Comparison of Structural Integrity Manual Phased Array Sizing Measurements Taken on Safety Nozzle “A” Versus LMT Manually Encoded Data

- Objective
 - Evaluate Structural Integrity Depth Sizing Measurements using LMT Manually Encoded Data
 - Determine if any of the reported flaws are connected to inside surface
 - Determine origin of tip signals reported

Location 15 Comparison at 14.0"

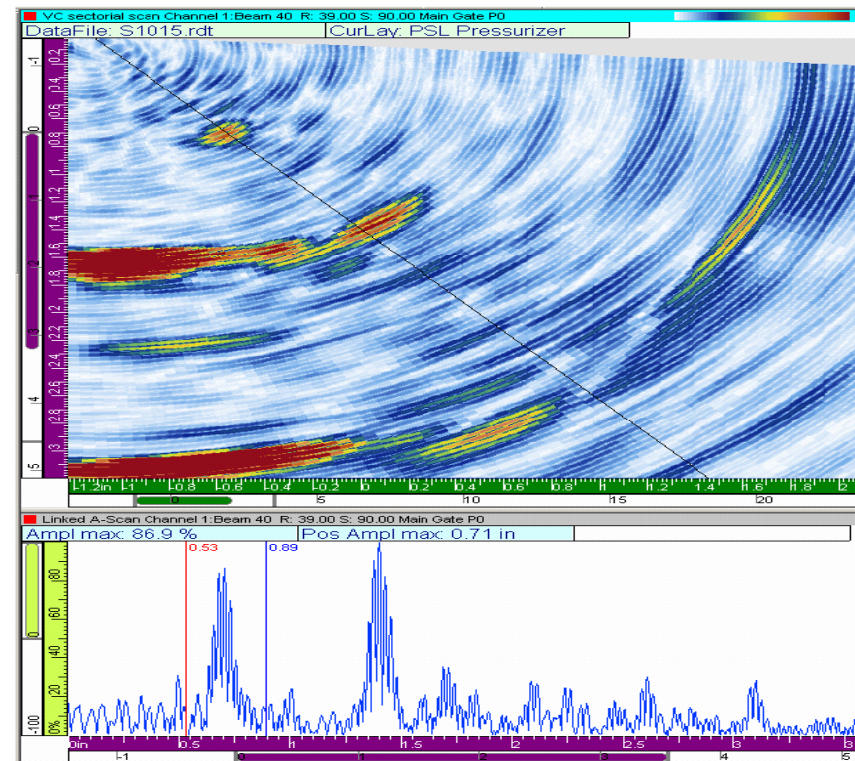
- Not detected circumferential Measurement may be off on manual report

Location 18 Comparison at 17.0"

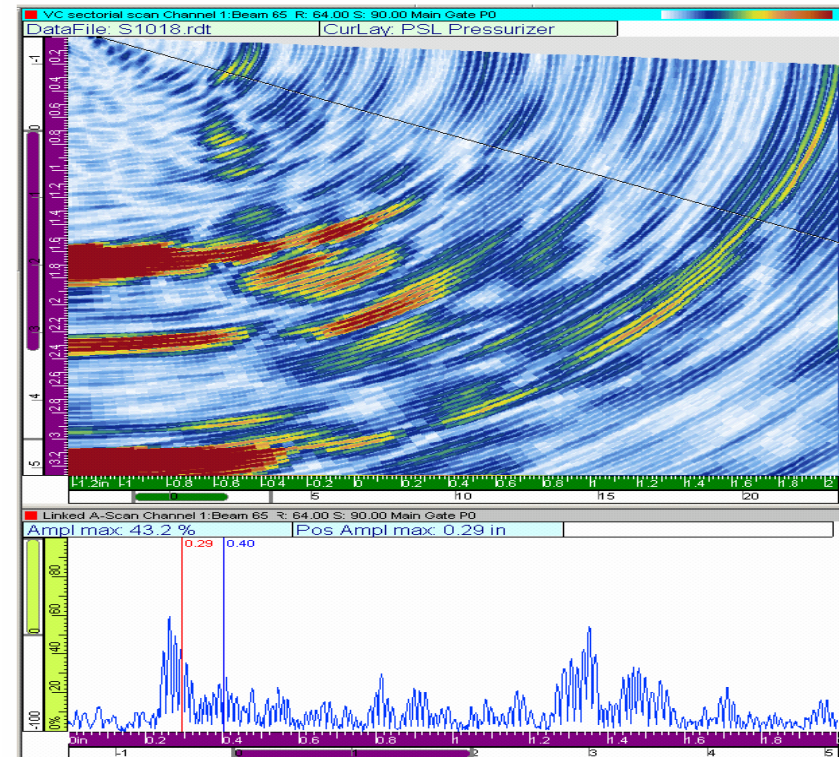
- Unable to resolve indication in this area suspect circumferential position may be off. From data it appears to be an additional feature of same flaw measured at 16.0"
